END OF ADDENDUM NUMBER ONE (1)

CIVIL PLANS	
CCD PROJECT	23043.10
DATE ISSUED	August 6, 2024
DATE REVISED	August 15, 2024
#	1

CLINTON PARKS - PHASE I
 CITY OF CLINTON
 TRACEWAY PARKS & KIDS TOWNE PARK

2 OVERALL HVAC PLAN - BUILDING 3 (ALTERNATE #3)
 M101 1/4" = 1'-0"

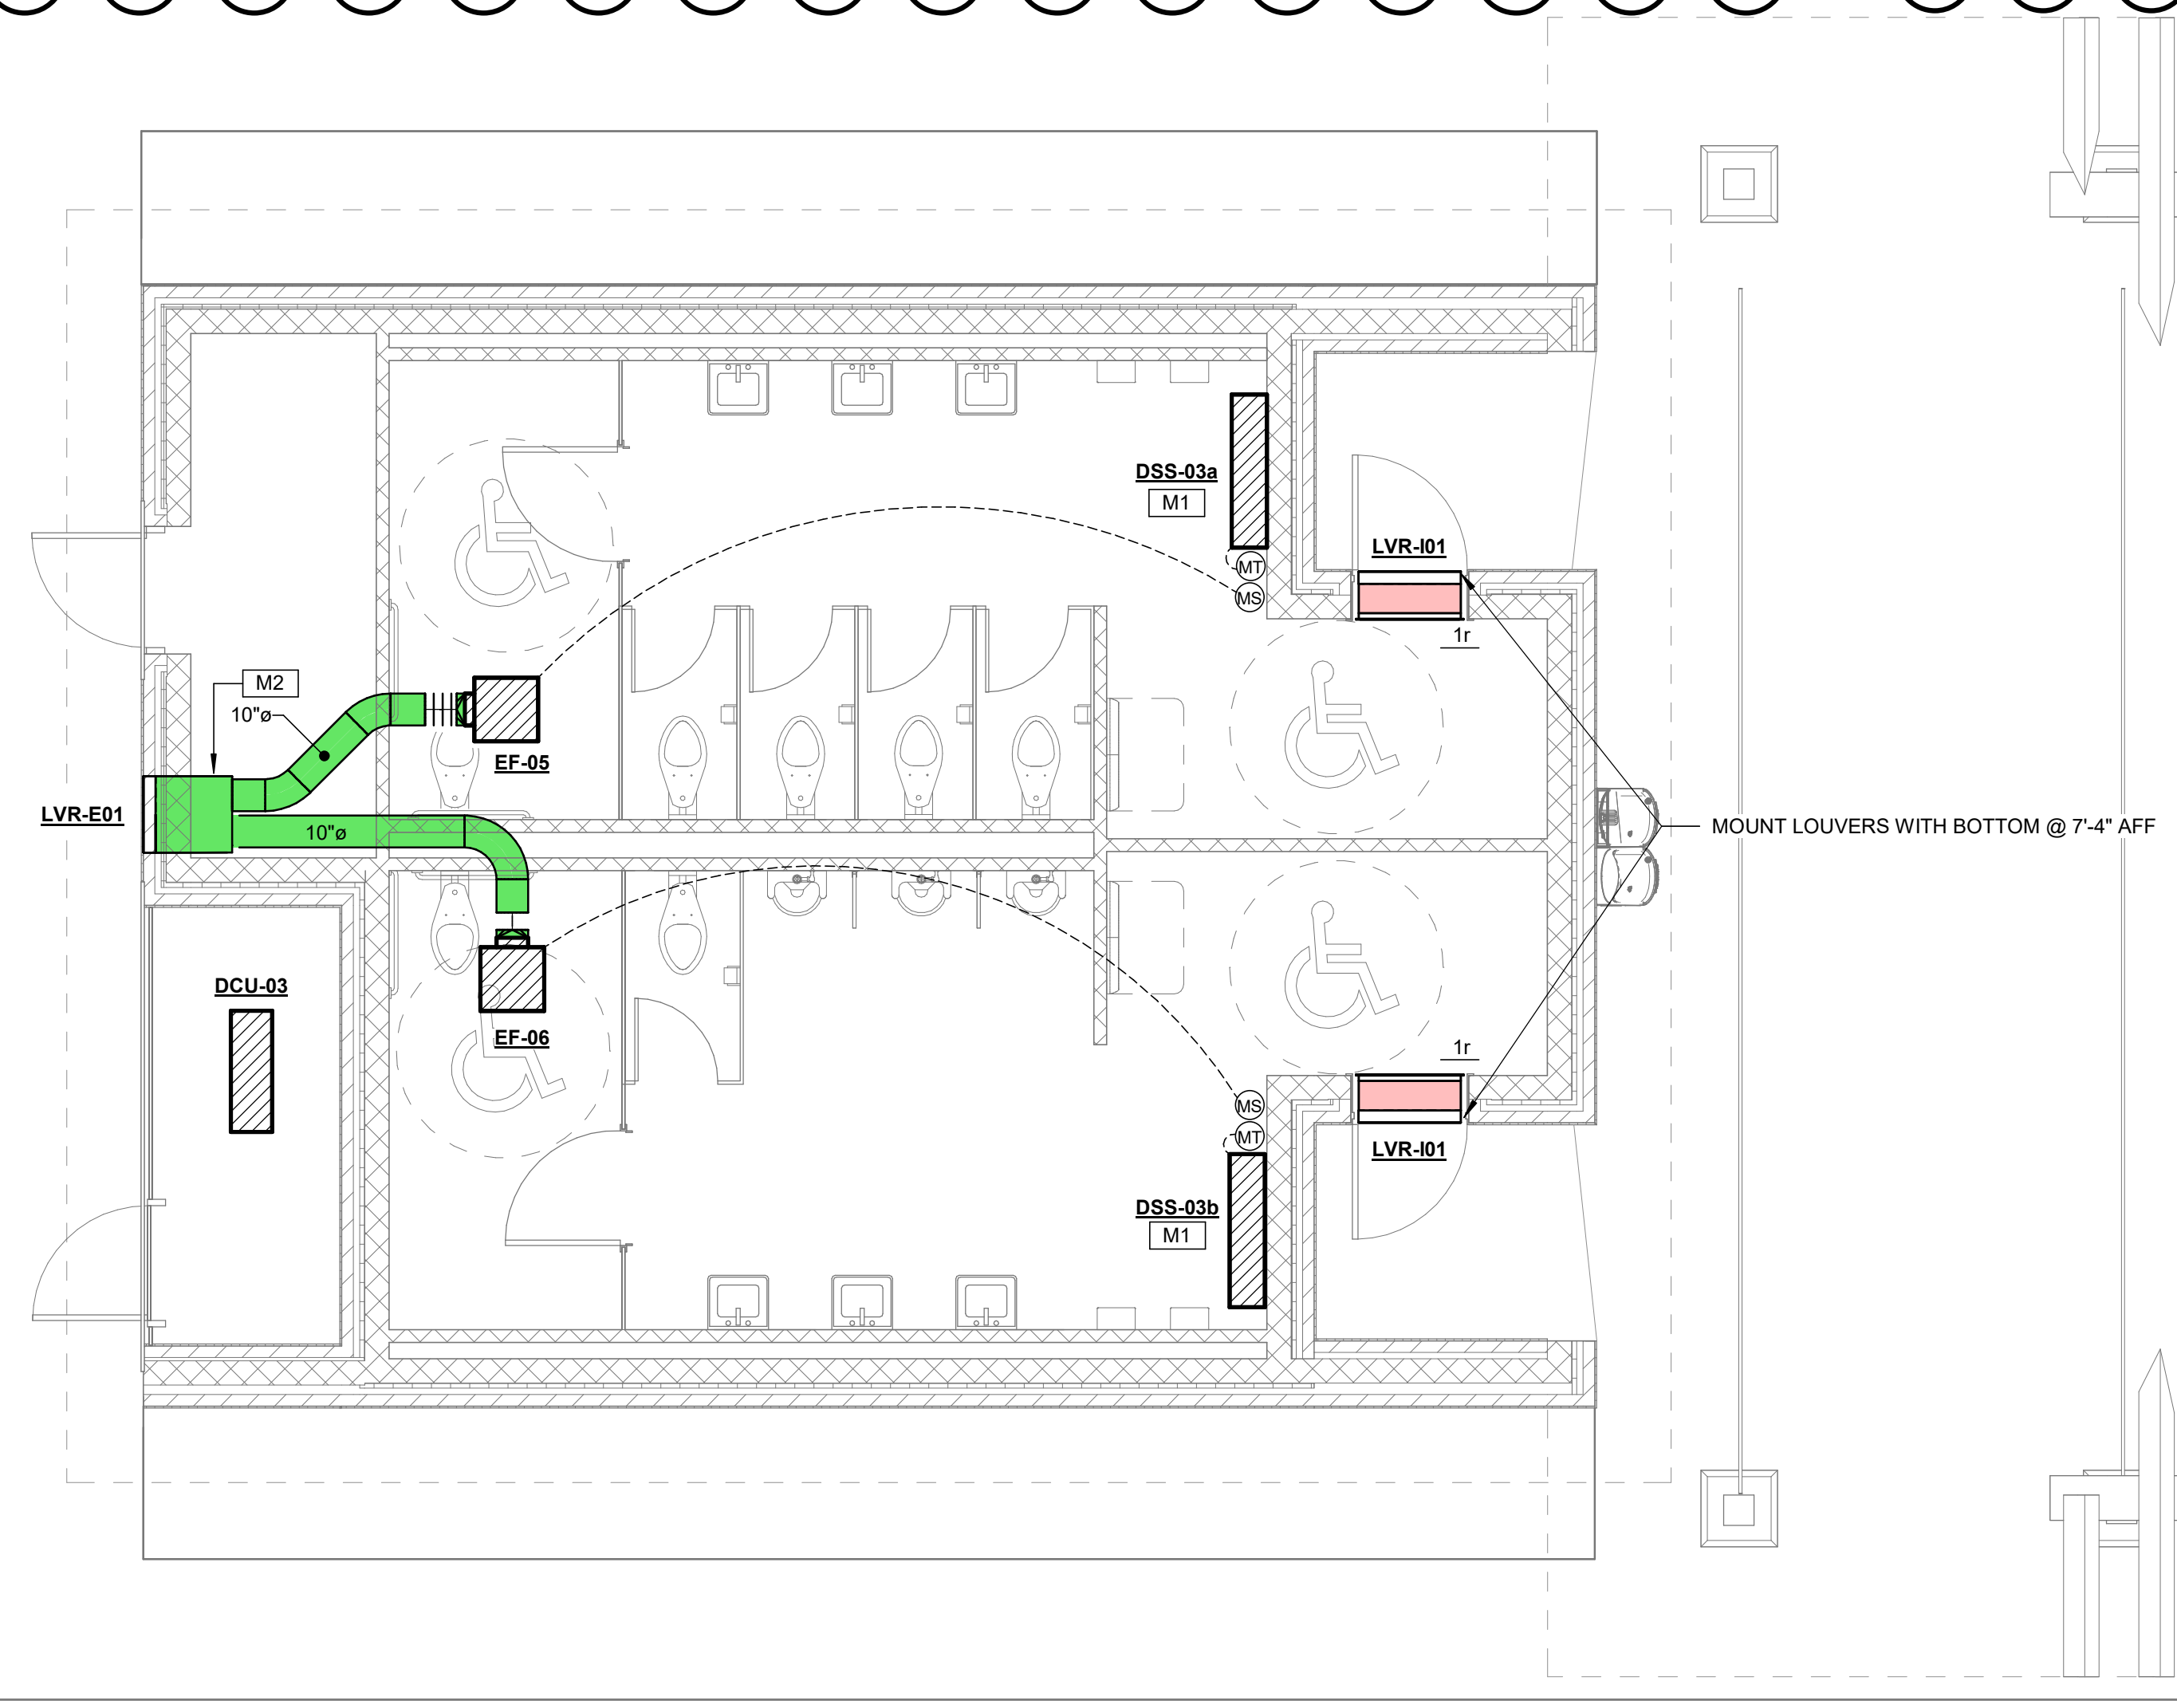
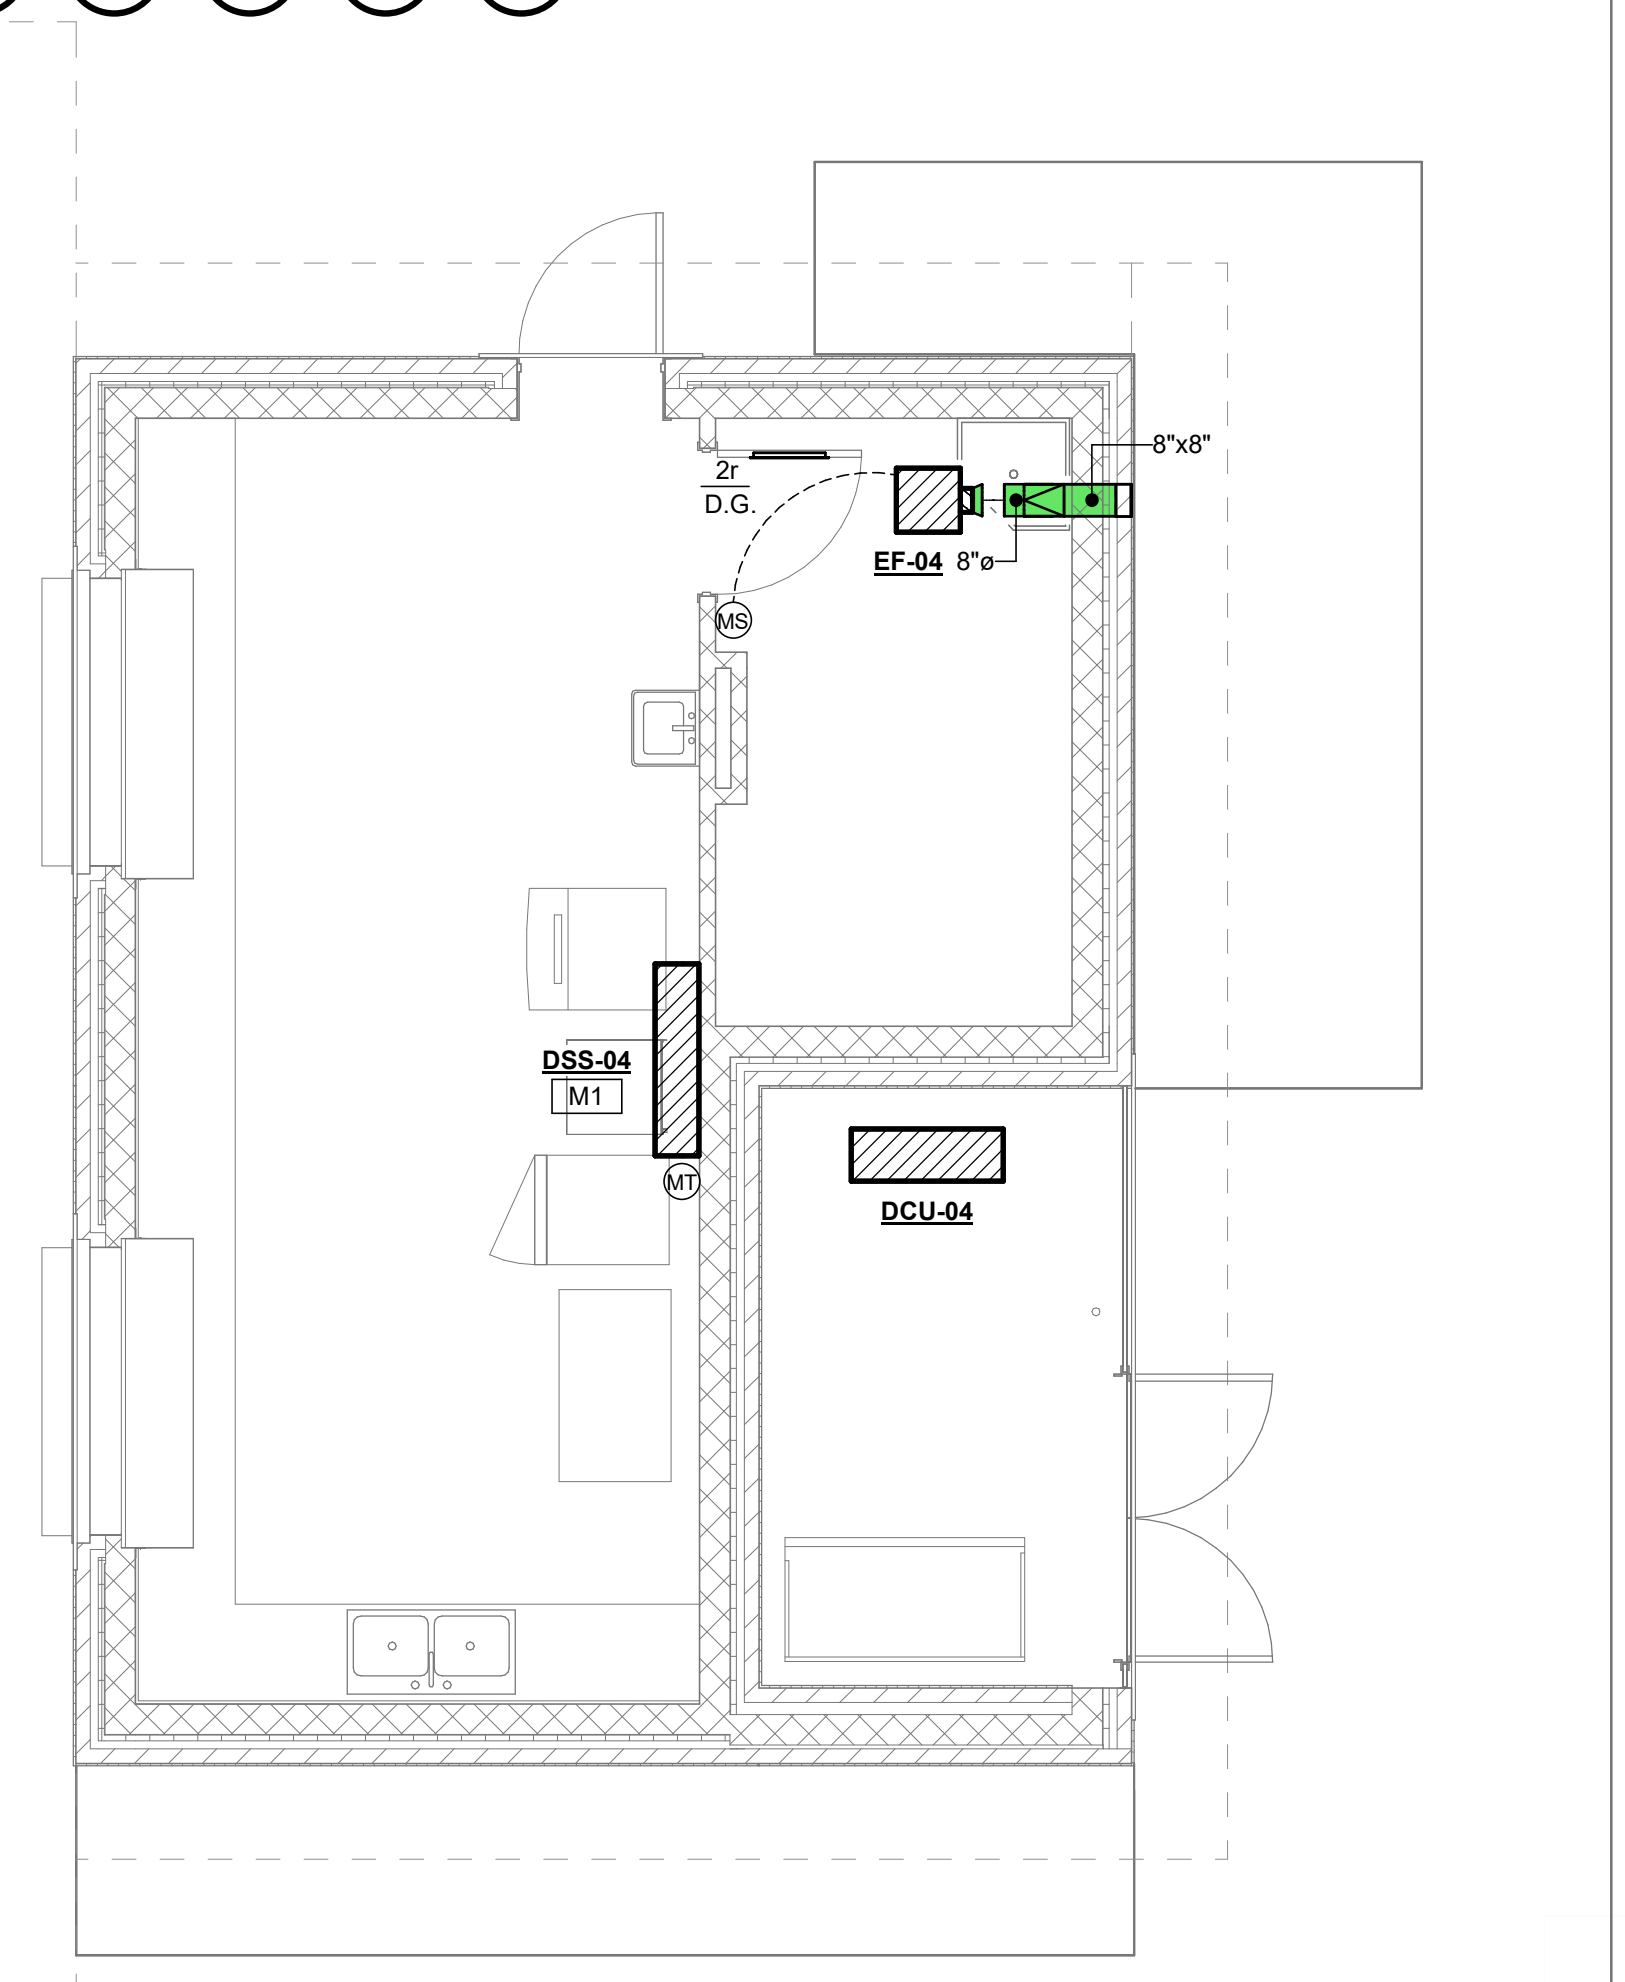
18. **DRAWING M101 HVAC, PLANS** – Replace with attached M101 R1 dated as revised August 15, 2024.
